Press release n.4 of 28/03/2024

Subject: **Regulation clarification Trofeo Easykart 2024**

- **CATEGORY EASYKART 100 - 125 – SUPPLEMENTARY SEAT SUPPORTS**

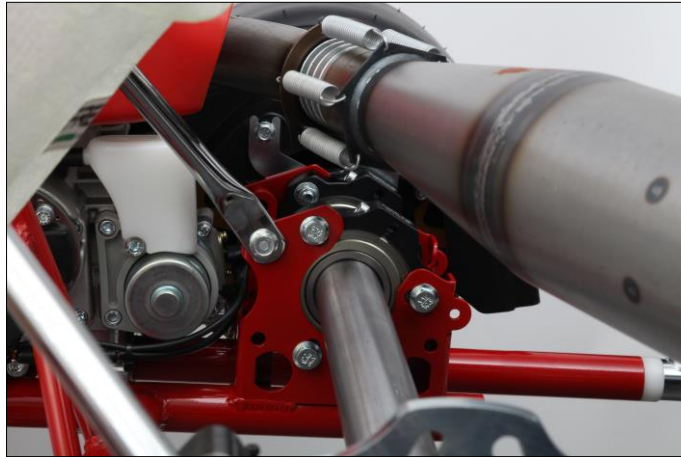
For Easykart 100 & 125 participating in the Trofeo Easykart 2024 must be fitted with n.2 supplimentary seat supports, original FREELINE “lenght is free” , must be fixed, one on the left & one on the right, from the bearing support to the seat **WITH ORIGINAL SUPPLIED HARDWARE** as below:

Attachment to seat;

- n. 1 Screw – VSPM6X25
- n. 1 Counter sunk washer M6 – cod. 20.3615.10-LU
- n. 1 Sat washer – cod. 20.7145.10
- n. 1 Washer – RPN-M6
- n. 1 Nut – DEA-M6A

Attachment to chassis;

- n. 1 Screw – VTEM8X45
- n. 1 Washer – RPN-M8X17X1,5
- n. 1 Nut – DEA-M8A
